## Amendment proposals to CEVNI based on recent amendments to RPNR (as of 1 June 2018) \*\* \*\*

### Transmitted by Belgium

*Data to be entered in the Inland AIS device : indication of the navigational status and the position acquisition point on the vessel*

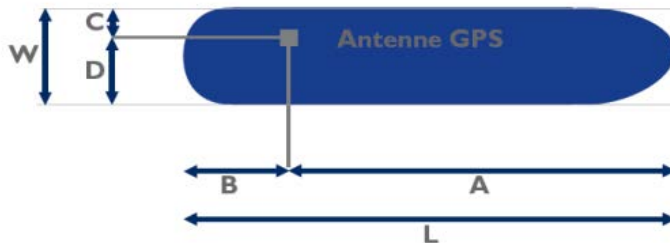
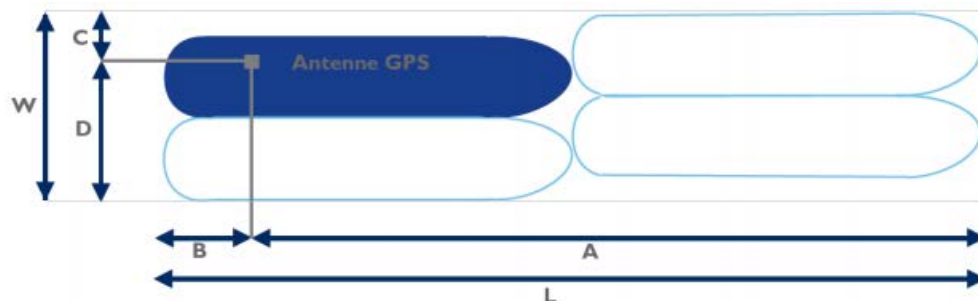
The boatmaster must enter the values of A, B, C and D with an accuracy of 1 m.

The dimension A is oriented towards the bow.

Indications concerning the values of W, L, A, B, C, D of a vessel

Indications concerning the values of W, L, A, B, C, D of a convoy

- (a) Overall length;
- (b) Overall beam;
- (c) Type of convoy **in conformity with the Vessel Tracking and Tracing Standard for Inland Navigation**;
- (d) Navigational status **in accordance with [annex 11]**;
- (e) Position acquisition point on the vessel **in metre accuracy**.
